#0692 - EL PASO COUNTY, CO
 6809 SPACE VILLAGE AVENUE
SITE DEVELOPMENT PLAN

DATE: 09/08/2017
 SHEET NUMBER: C1.1
 1 OF 1

Markup Summary

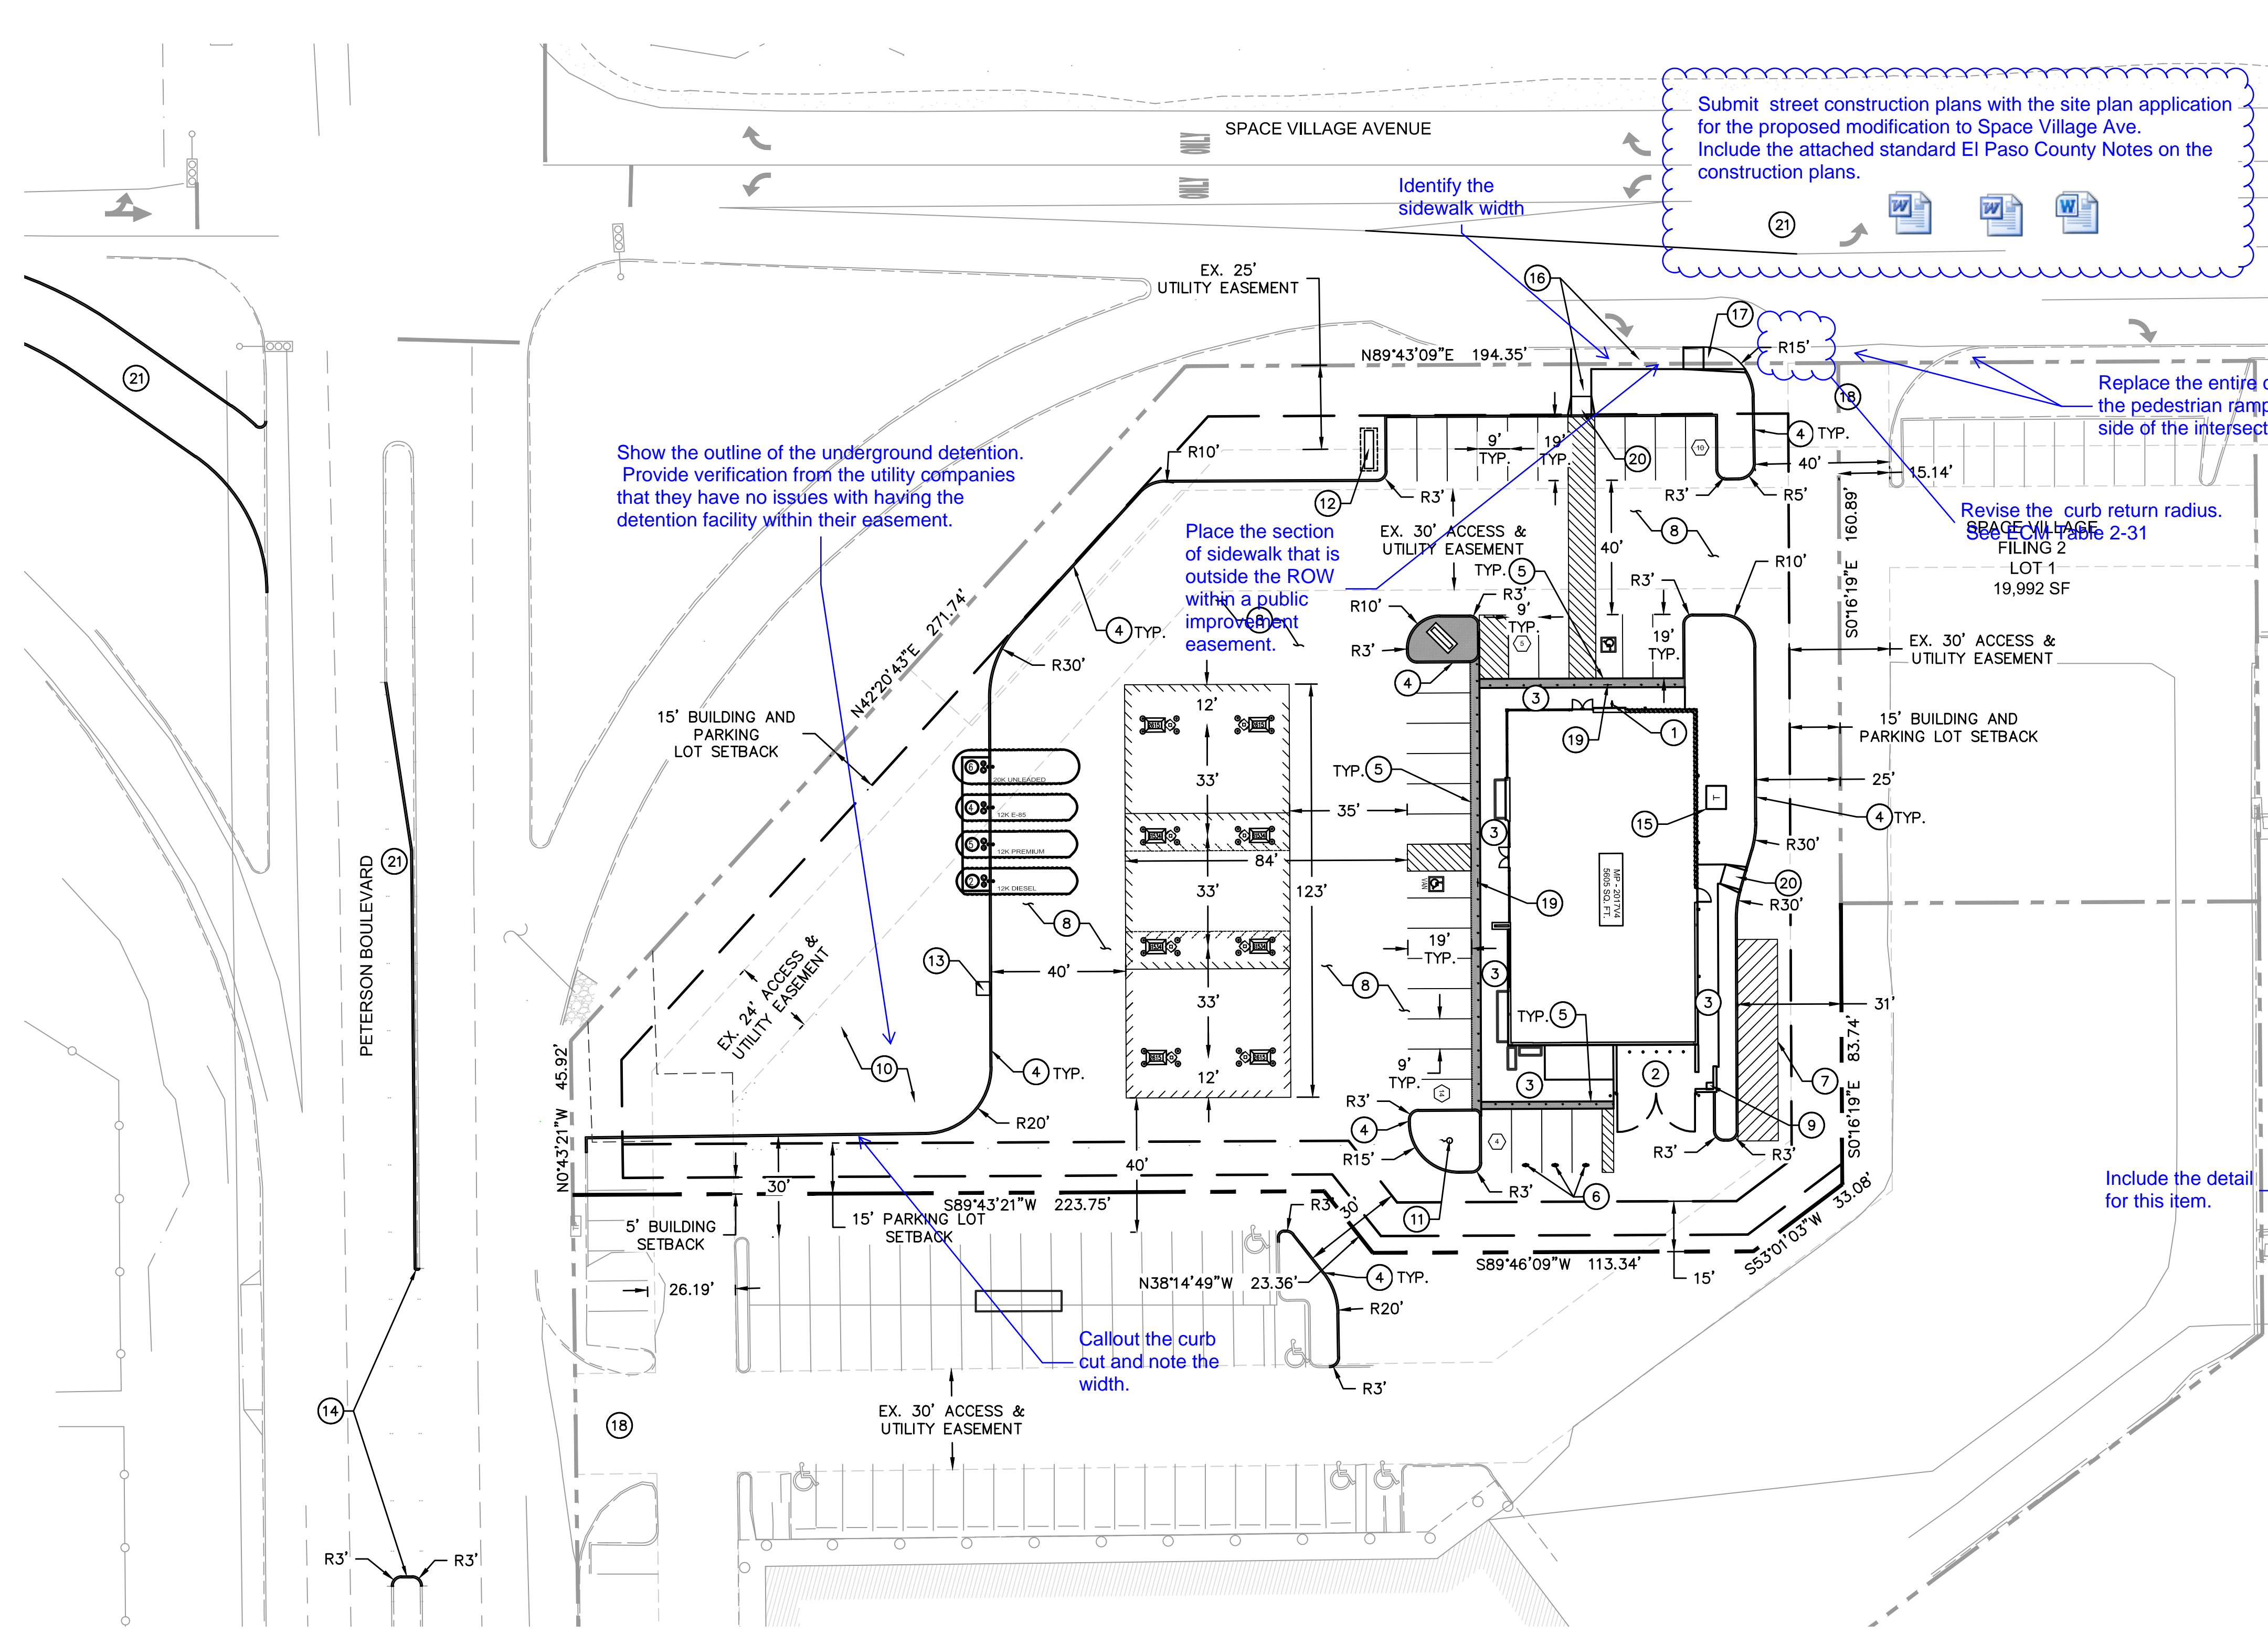
Contact CDOT and the City of Colorado Springs regarding their submittal requirements for the proposed improvements to Peterson Road and US-24 off-ramps.

All the offsite improvements must be approved prior to or concurrent with the site plan.

Submit street construction plans with the site plan application for the proposed modification to Space Village Ave. Include the attached standard El Paso County Notes on the construction plans.

Add "Refer to the Grading and Erosion Control Plan."

Approval from CODT, Colorado Springs required

Reference the specific County Ramp details.

Include the detail for this item.

Callout the curb cut and note the width.

Identify the sidewalk width

Show the outline of the underground detention. Provide verification from the utility companies that they have no issues with having the detention facility within their easement.

Replace the entire crossspan and the pedestrian ramp at the east side of the intersection.

Revise the curb return radius. See ECM Table 2-31

Place the section of sidewalk that is outside the ROW within a public improvement easement.
